**Comment Response Matrix**  
0, 12197, 12155, 12045, & 12029 Coleraine Drive,  
8522, 8576, 8602 Mayfield Road,  
Northeast Corner of Mayfield Road and Coleraine Drive,  
Town of Caledon  
August 2025

0, 12197, 12155, 12045, & 12029 Coleraine Drive,  
8522, 8576, 8602 Mayfield Road,  
Northeast Corner of Mayfield Road and Coleraine Drive,  
Town of Caledon  
Weston File: 10846  
August 2025  
City File: PAR-DPP-2024-00206

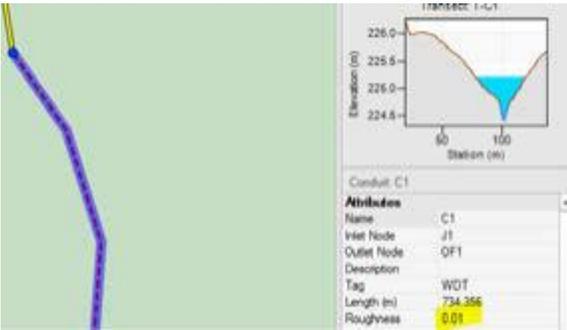
3. To account for the additional runoff between two flow nodes, TRCA typically applies the downstream peak flow to the upstream flow node location to determine the flood hazard. Consistent with standard practice, the EA project followed TRCA’s standard by applying the downstream Regional peak flow of 14.52 m <sup>3</sup> /s at Mayfield Road to the upstream section of the watercourse determining the flood hazard extent accordingly. However, the applicant has not adhered to this standard and applied a peak flow of 10.2 m <sup>3</sup> /s. Please revise the peak flow used in the analysis utilizing the downstream Regulatory flow to the upstream section of the channel.	GEI Consultants / Greck	Greck: Note that 14.52m <sup>3</sup> /s comes from Flow Node 24.11 (HYD#7435, page 150 in TRCA Humber River Hydrology Update) and is not the flow from Catchment 24.11 (HYD#7419 in Humber River VO model). As such, using 14.52m <sup>3</sup> /s is not appropriate for the purposes of the Rainbow Creek – Simpson Road extension design. Catchment 24.11 (HYD#7419), which has a regional peak flow of 10.2m <sup>3</sup> /s corresponds to the Equity Pond drainage area. This is further explained and referenced in the updated report provided.

4. As part of the approved EA, the existing flood storage was estimated to be 12,090 m <sup>3</sup> . TRCA staff reviewed the submitted PCSWMM model for the proposed watercourse enclosure and estimated the flood storage to be provided by the pipe to be approximately 4,110 m <sup>3</sup> . This indicates a loss of approximately 7,980 m <sup>3</sup> of flood storage due to the watercourse enclosure. This reduction in storage is significant and will have a negative impact on downstream peak	GEI Consultants	Greck: Channel enclosure is no longer being proposed. The proposed, new open channel design offers more than hydraulic storage but also hydrologic attenuation. See updated report.
